Three Mile Island Nuclear Station, Unit 2 (TMI-2)  
Operating License No. DPR-73  
Docket No. 50-320  
Early Defueling Safety Evaluation Report  
Response to Comments

Attached are responses to your comments on the Early Defueling Safety Evaluation Report (SER) transmitted by your letters dated July 29, 1985, and August 13, 1985. Note that additional input is being prepared to respond to your question concerning onsite testing of canisters and will be submitted under separate cover.

Figure 1: Knockout Canister Connect Assembly

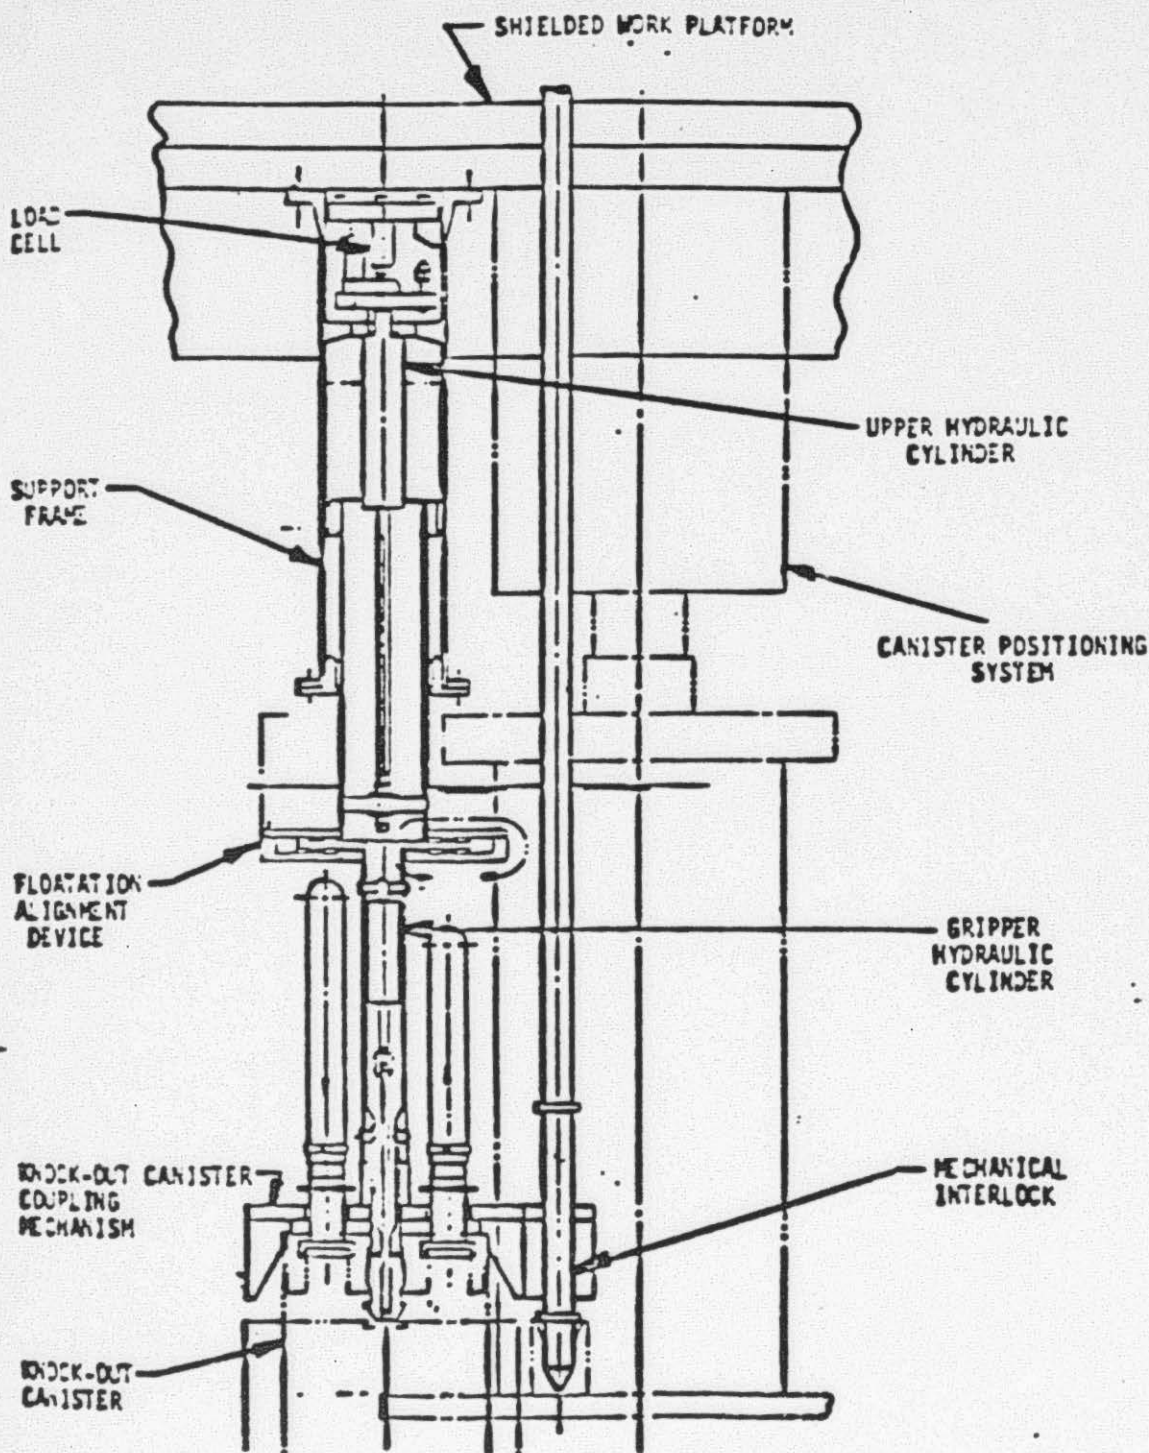
4. Comment: Describe the equipment used and the methods for weighing the three types of canisters during defueling operations and following dewatering in the fuel handling building.

Response: Knockout Canisters - Knockout canisters are weighed during all vacuuming operations using the knockout canister connect assembly module, which is illustrated in Figure 1. The knockout canister connect assembly module is mounted to the underside of the shielded work platform. After a mechanical interlock between the Canister Positioning System (CPS), which is carrying the knockout canister, and the knockout canister connect assembly module has been established, the knockout canister is lifted from the CPS a predetermined distance (approximately 1 inch) to allow weighing of the canister. The existing load cell (0-7500 lb. range,  $\pm 0.5\%$  accuracy) sends a signal to the Control Console on a continuous basis that reflects the weight of the knockout canister. A load cell readout is provided on the Control Console.
